Inspection Report

Project	LBST Jetty Pile and Headstock Remediation
Date	25th July 2026
Inspected by	David Edelman
Areas inspected	Pilebent 270 Welding underway Pilebent 271 abrasive blast and first coat Pilebent 273 progress inspection Pilebent 274 Inspect proposed weld repairs Pilebent 275 progress inspection Pilebent 281 Coating inspection and progress
Weather conditions	Fine and dry. Moderate wind and swell to approx. one metre

1. PB270 – abrasive blasting and painting

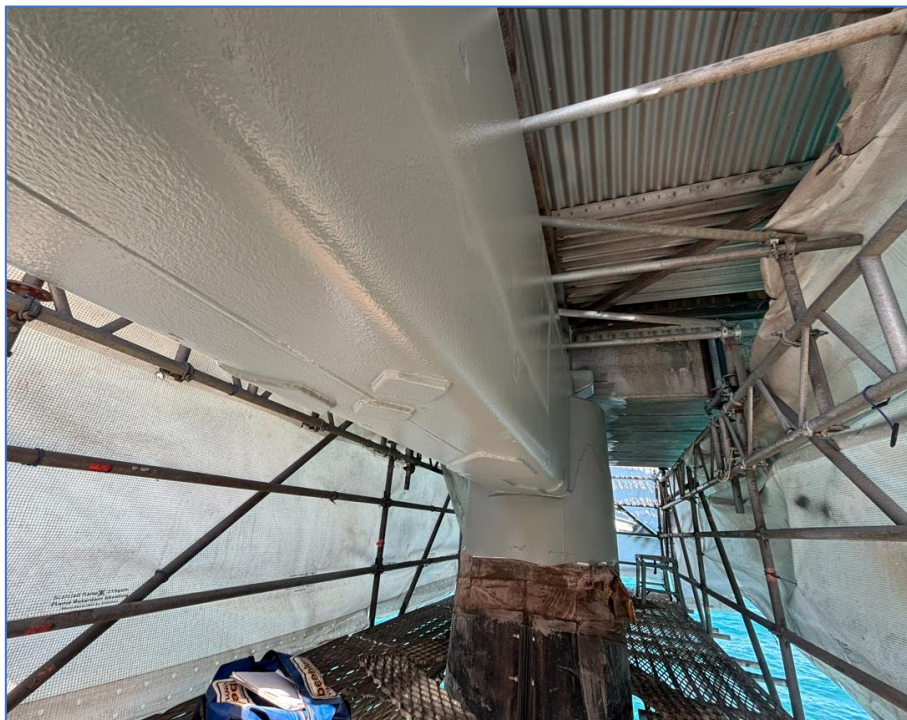
- Very clean blast
- Hole along weld not visible until blasting was completed. Was repaired and reblasted prior to coating
- Stripe coating carried out
- Masking of gap between sliding foot and brass plate

3. PB274 – Weld patches proposed

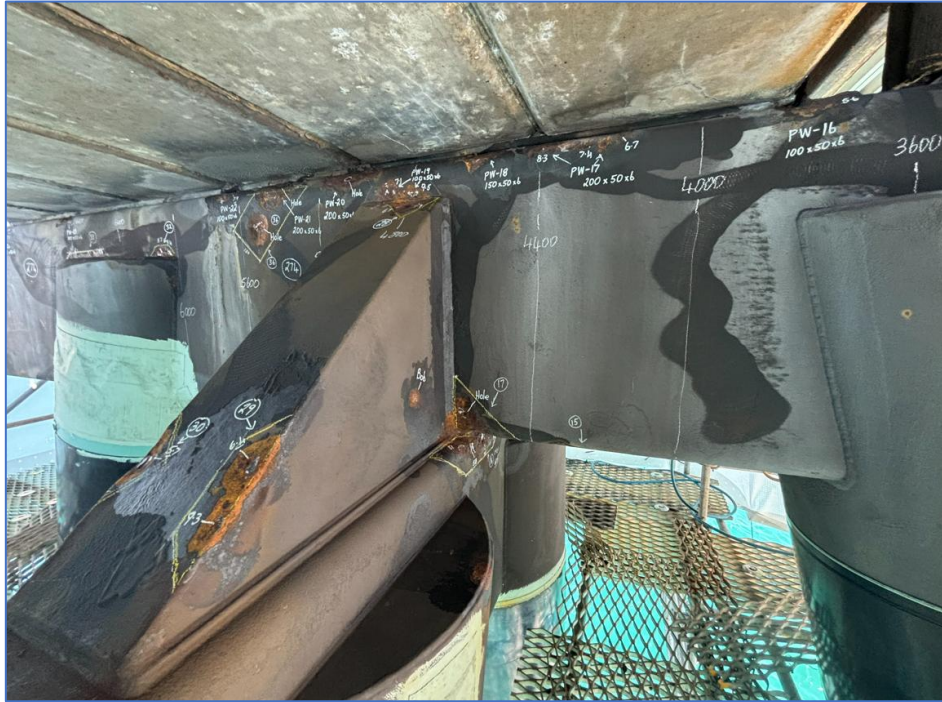
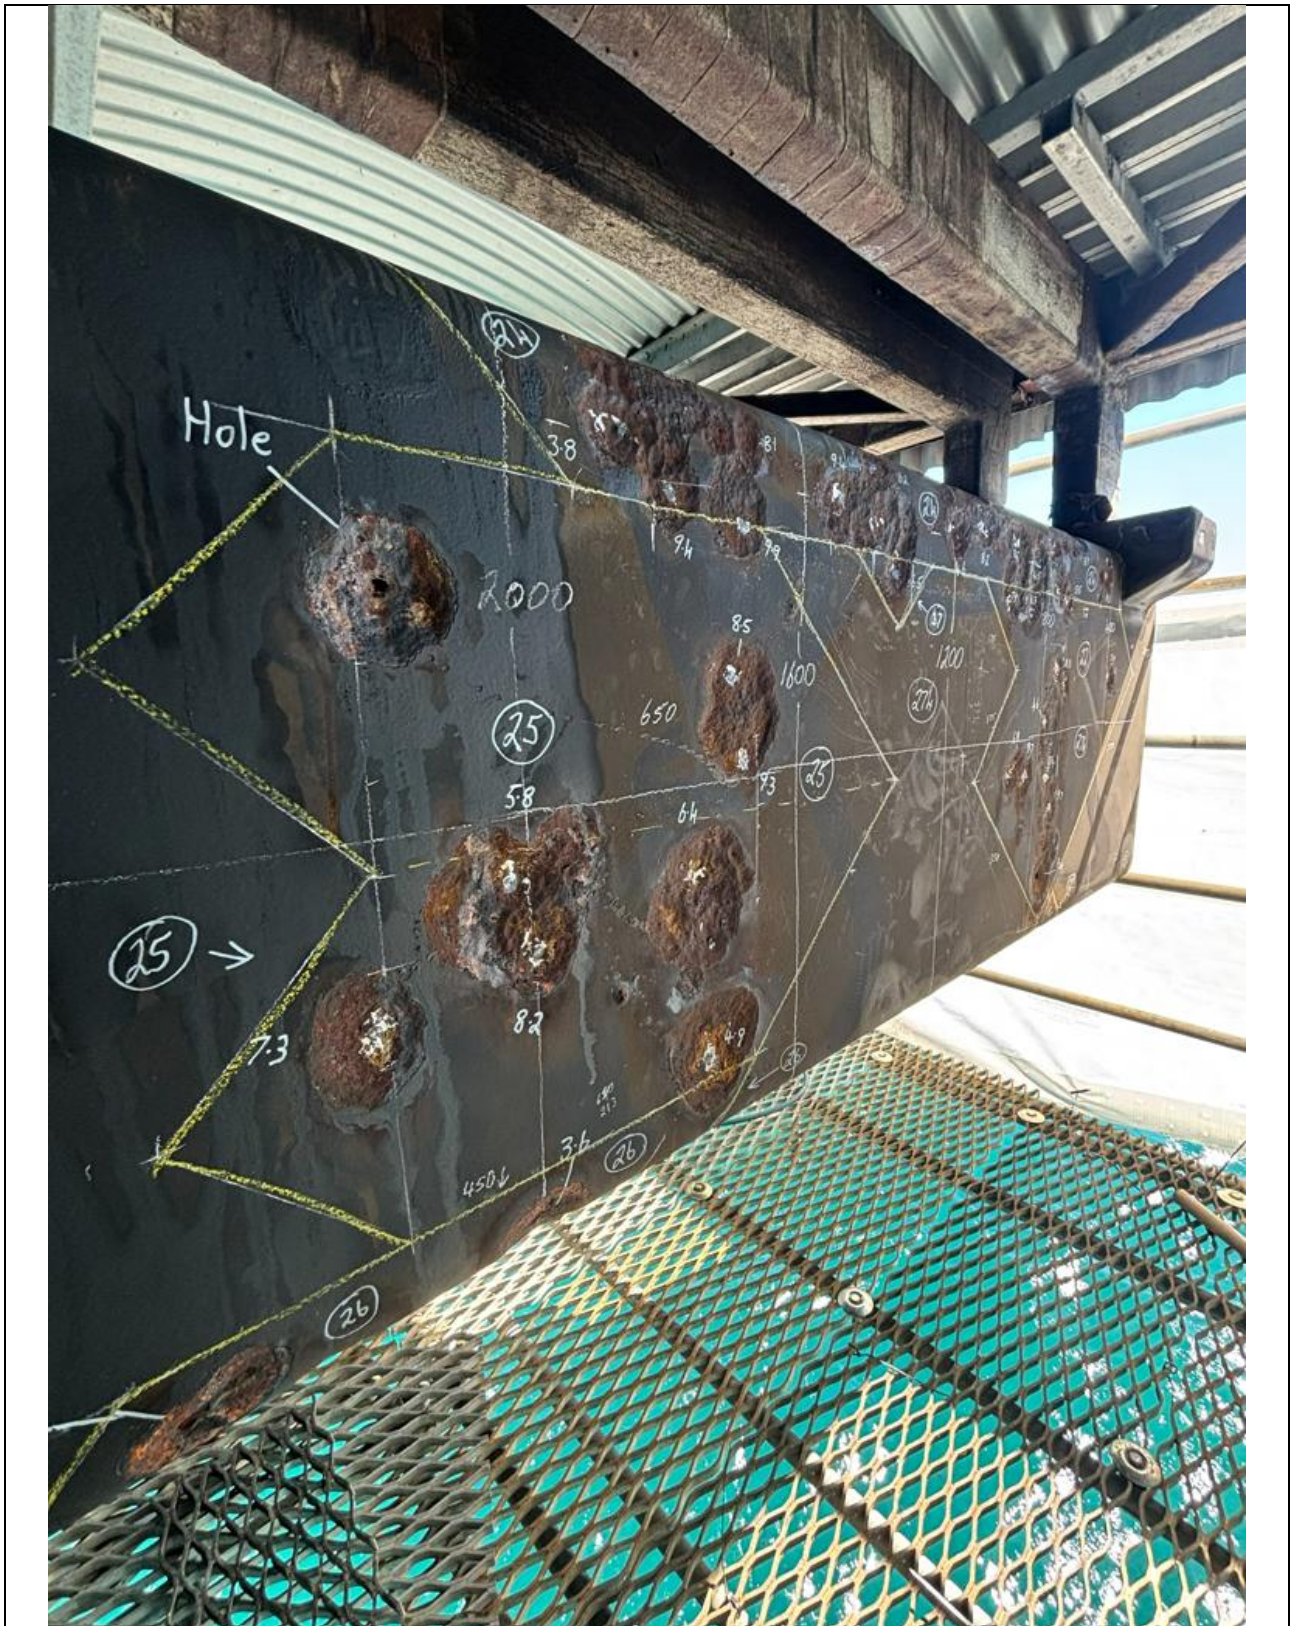
- Patches approved
- Additional patch adjacent to patch 15
- PB274 is a good example of where an allowance of 8mm vertical edge plates (rather than 45 degree angle) on northern end of headstock may allow reduced repair plate qty. It has extensive low areas in a vertical line. These are better treated as one large plate with the 45 degree requirement but may be smaller plates if vertical edges were accepted.
